Model: Kir-C3 GW Expansion Unit (B84317)		Date: 19-Sep-07	No.: MB867001
Modified Article: Parts Catalog Correction		Prepared by: Y.Yoshida	
From: 1 <sup>st</sup> Tech. Support Sec. Service Support Dept.			
Reason for Modification:	<input checked="" type="checkbox"/> Parts catalog correction <input type="checkbox"/> To facilitate assembly <input type="checkbox"/> Part standardization	<input type="checkbox"/> Vendor change <input type="checkbox"/> To improve reliability <input type="checkbox"/> Other	<input type="checkbox"/> To meet standards (      )

Model: Kir-C3 GW Expansion Unit		Date: 18-Mar-08	No.: MB867002
Modified Article: Part number correction		Prepared by: Y.Yoshida	
From: 1st Tech. Support Sec. Service Support Dept.			
Reason for Modification:	<input checked="" type="checkbox"/> Parts catalog correction <input type="checkbox"/> Vendor change <input type="checkbox"/> Other <input type="checkbox"/> To facilitate assembly <input type="checkbox"/> To improve reliability <input type="checkbox"/> To meet standards <input type="checkbox"/> Part standardization <input type="checkbox"/> Product Safety    (      )

Model: Kir-C3 Printer/Scanner Unit Type2000		Date: 2-Sep-08	No.: M

Page4

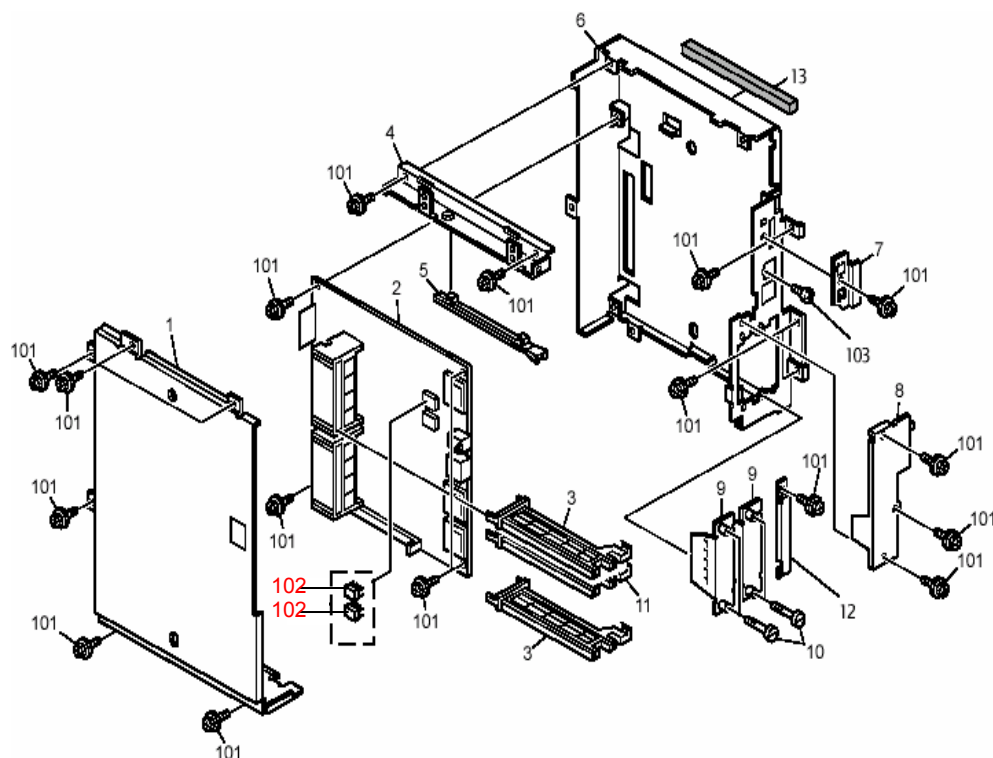
Please correct your Parts Catalogs as follows:

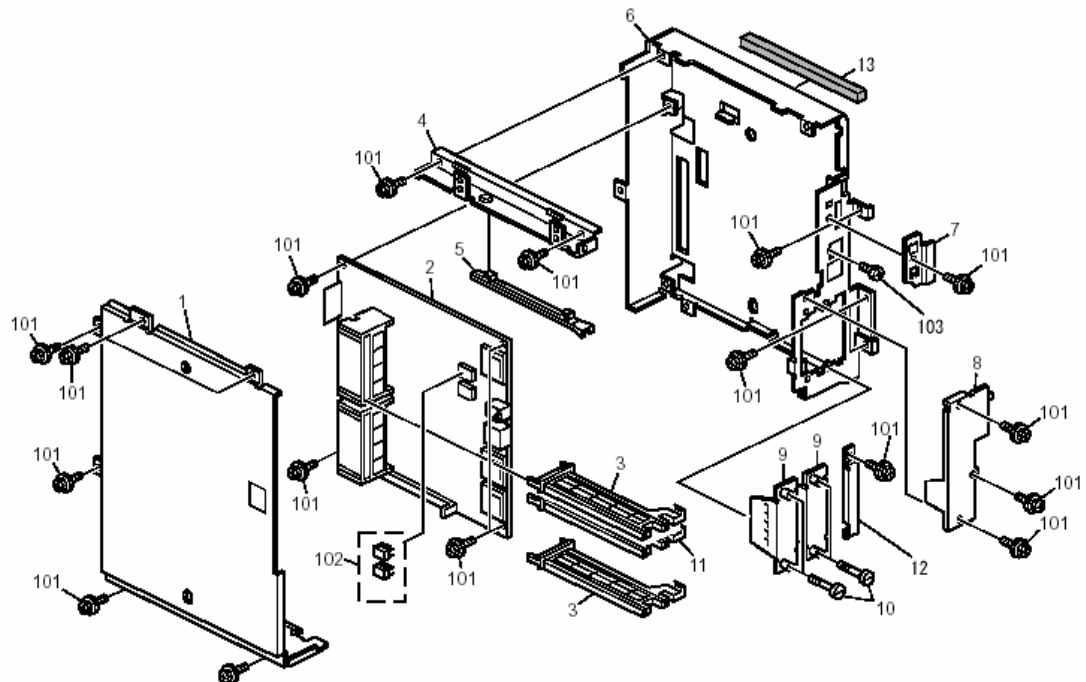
**Change:** The Controller software was changed.

**Reason:** To increase the reliability of the Controller Board (to ensure SC820 does not occur).

Old Part	NEW Part	Description	Q'ty	Int	Page	Index	Note
B8435727	B8435728	PCB:Type-DM:K-C3:Ass'y	1→1	O/O	5	2

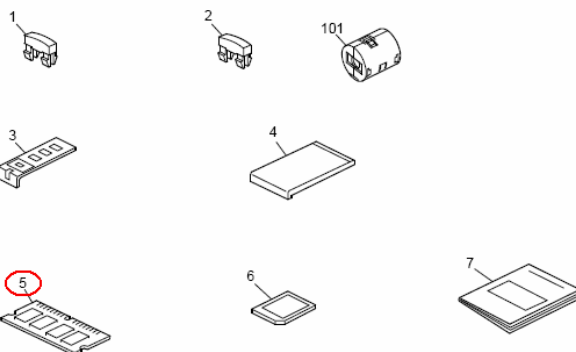
**Change/Reason:** Parts catalog correction

Old Part	NEW Part	Description	Q'ty	Int	Page	Index	Note
G3325730	G3325750	PCB:SDRAM-DIMM:256MB:CHN_SH:A SS'Y	1→1		3	5
